# RotorSport UK Ltd

## Service Bulletin

<b>SB No.: 040 issue 2</b>	CCAR No.: None	Classification: <b>OPTIONAL</b> or <b>RECOMMENDED</b> or <b>MANDATORY</b>
Aircraft type & model (applicability) RotorSport UK MT-03, MTOsport	Aircraft serial Nos. effected RSUK/MT-03/any RSUK/MTOsport/any

This service bulletin SB-040 describes how an MT-series aircraft may be upgraded to Rotorsystem II (with either the standard or TOPP variant rotors). Once the upgrade has been done then subsequently either the standard variant or the TOPP variant rotors may be fitted under the conditions of service bulletin SB-116 "RSII rotor interchange". Note that as the weight of each rotor variant is different the aircraft's AWC and weight placard must be amended accordingly, together with an application to CAA for amendment of the Permit-to-Fly.

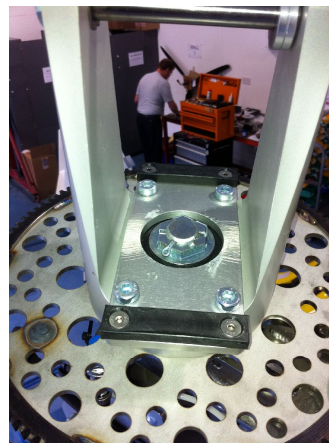
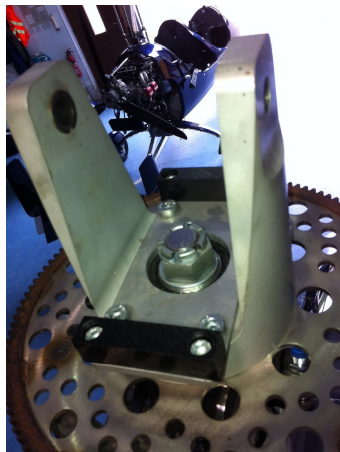
In 2011RSUK introduced RotorSystem II for fitment to MT-03, MTOsport and Calidus gyroplanes (and subsequently used the same system for Cavalon gyroplanes). This new rotor system has a service life 2,500 hours, a significant improvement over the original system's 700 hours. It is readily recognisable by the scalloped hub-bars, taller teeter tower and red end caps fitted to each blade. The rotor system was approved by CAA under modification MC-175.

The rotating parts of the original rotor system (RS1) on left and RotorSystemII on right  
Note the taller teeter tower, smaller teeter blocks and special castle nut of RotorSystemII

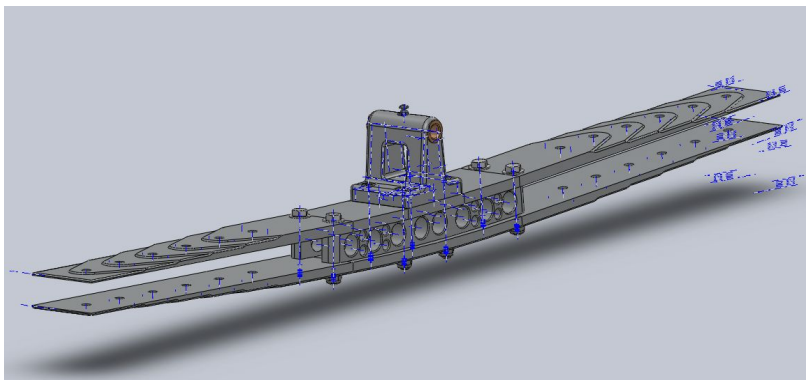
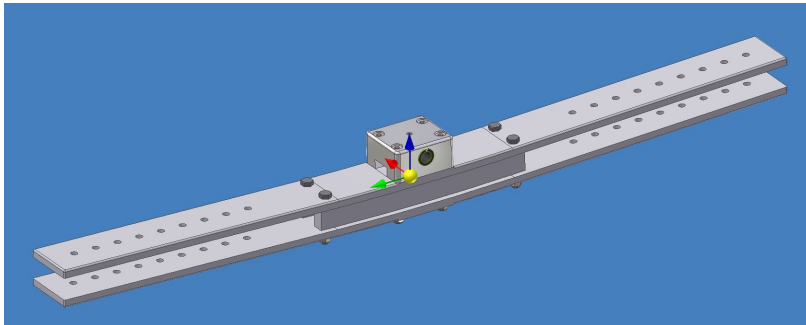
Important note: The new rotors by themselves (identified by red end-caps or blue end-caps) are not directly interchangeable with any other rotors having black, grey or orange end-caps. In embodying this SB-040 the whole rotor system (consisting of rotating parts and teetering parts) must be changed (see photos below).

Rotorsystem II 7mm teeter-stop (MTOS shown)

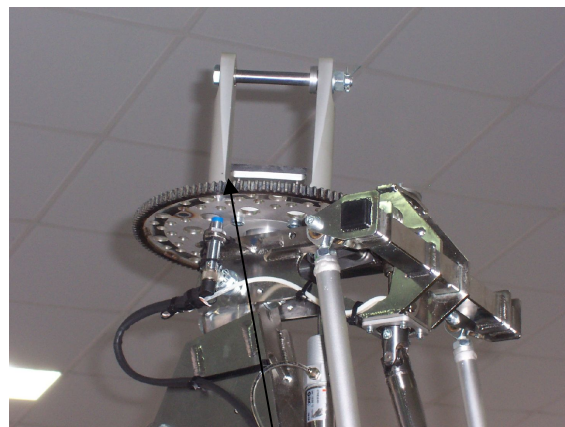
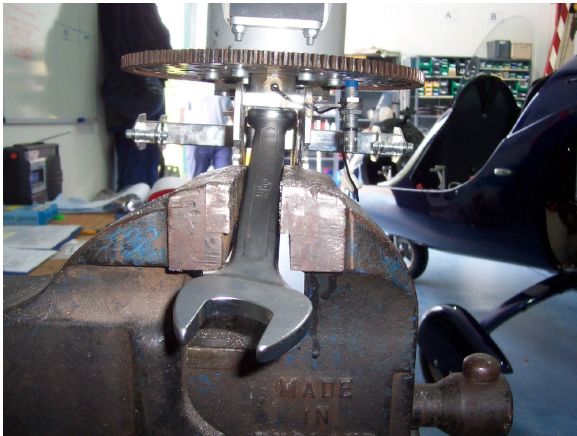
Original 18.8mm teeter-stop (MT-03 shown)

Schematic view of Rotorsystem II. Note the different length bolts

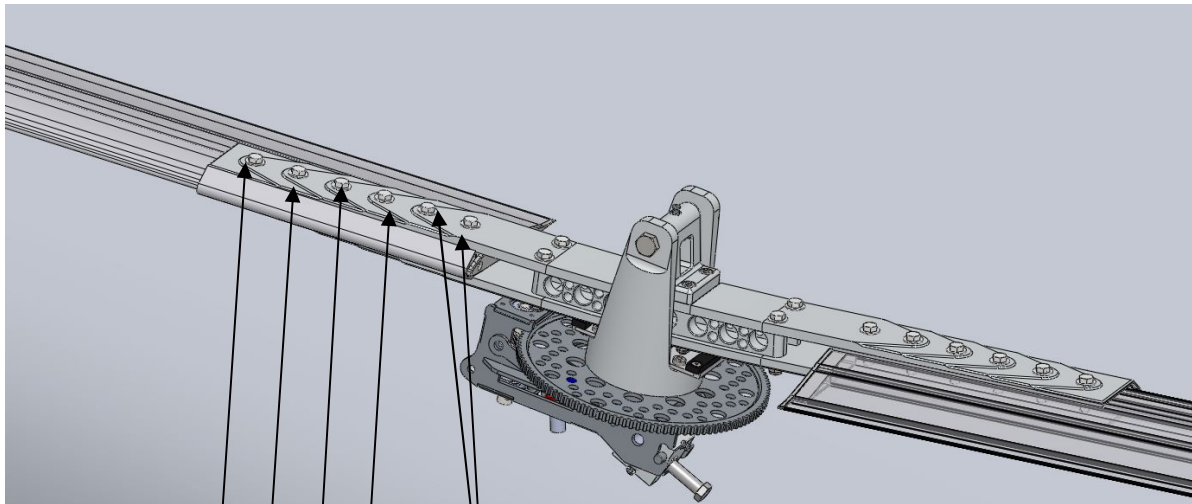
**WARNING!** It is important to fit the correct length bolt in the associated hole! Fitting the wrong length bolt may result in insufficient safety protrusion through the nylock nut, or that the nut jams on the shank of the bolt before the joint is properly tightened.

- Bolt BT3697, 49mm
- Bolt BT3698, 52mm
- Bolt BT3699, 55mm
- Bolt BT3670, 58mm
- Bolt BT661, 60mm long
